Mezzanine update

# Mezzanine and cryostat

# Plan view

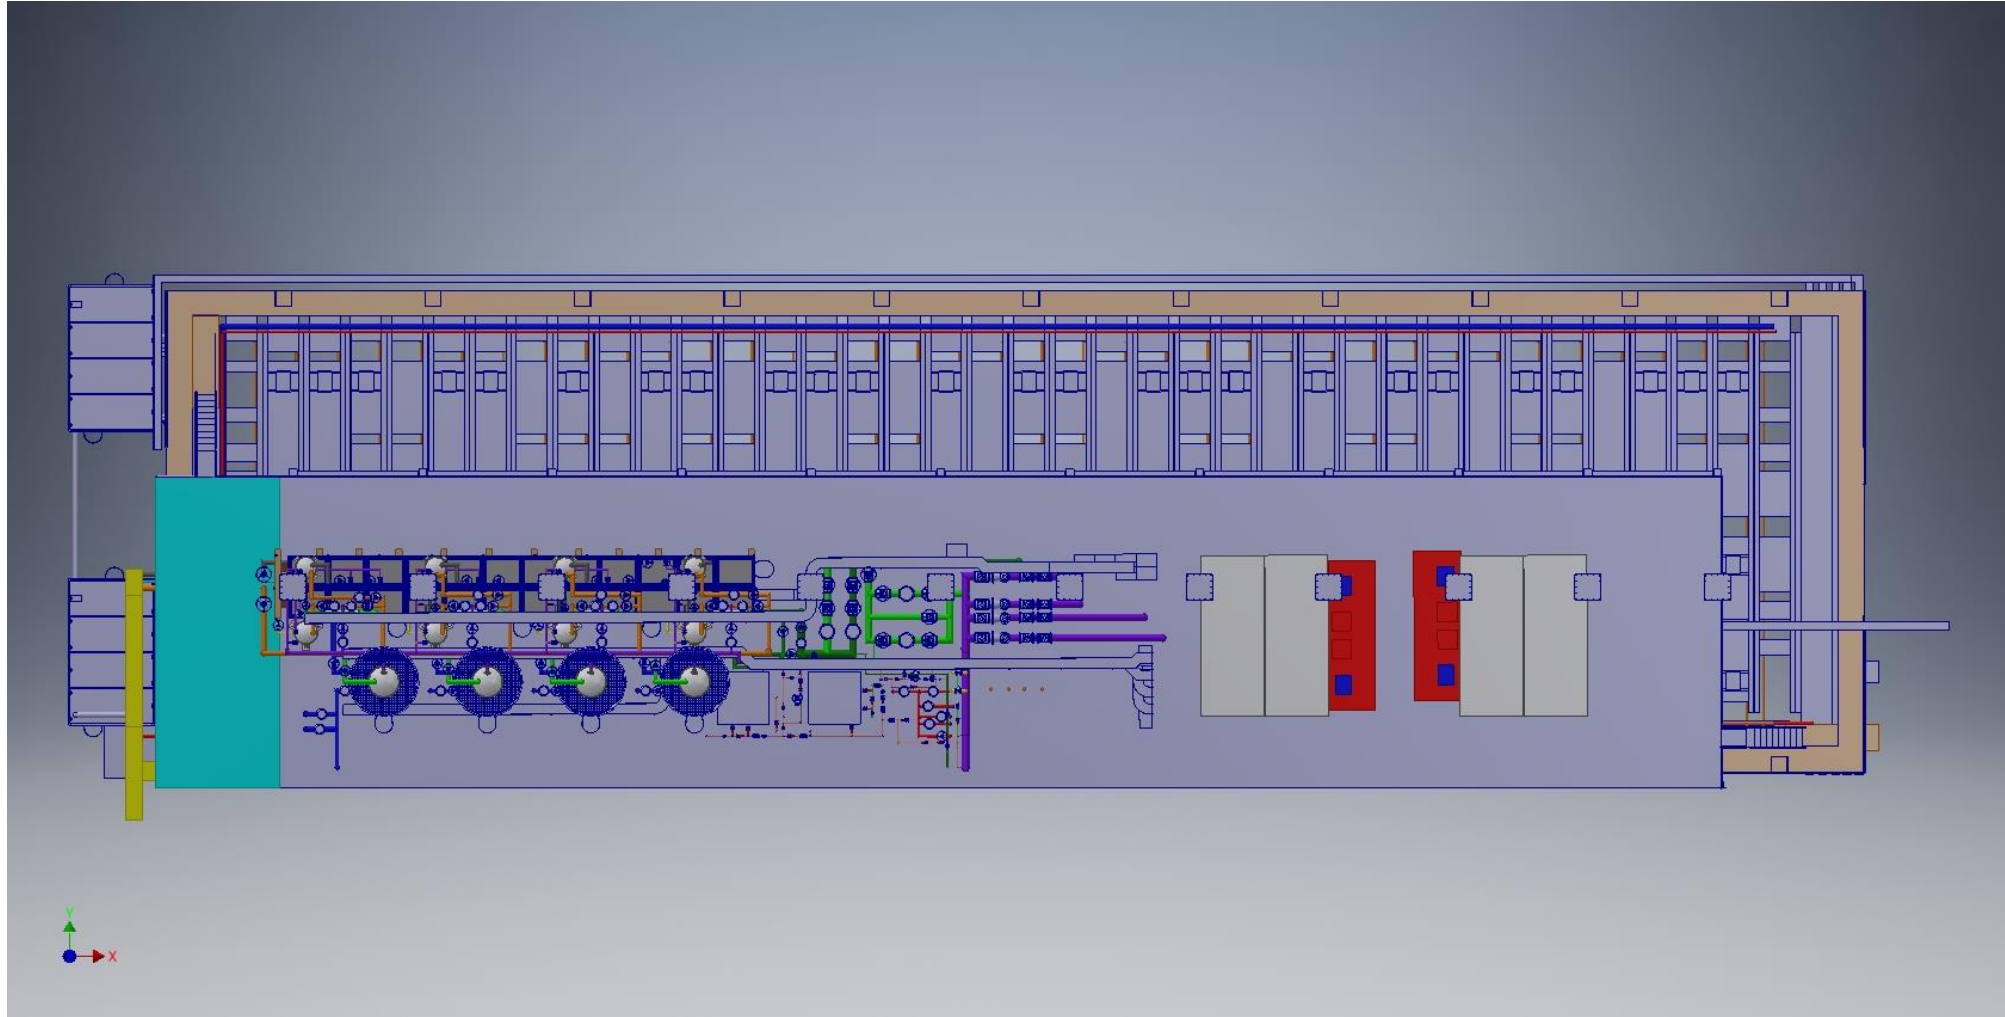
Extension – adds 10 m

- Changes to CF – adds 2 crown support points and 2 wall support
- Provides additional space for other equipment, barracks, etc. TBD
- Allows for the same design of mezzanine and proximity cryogenic systems for all cryostats.
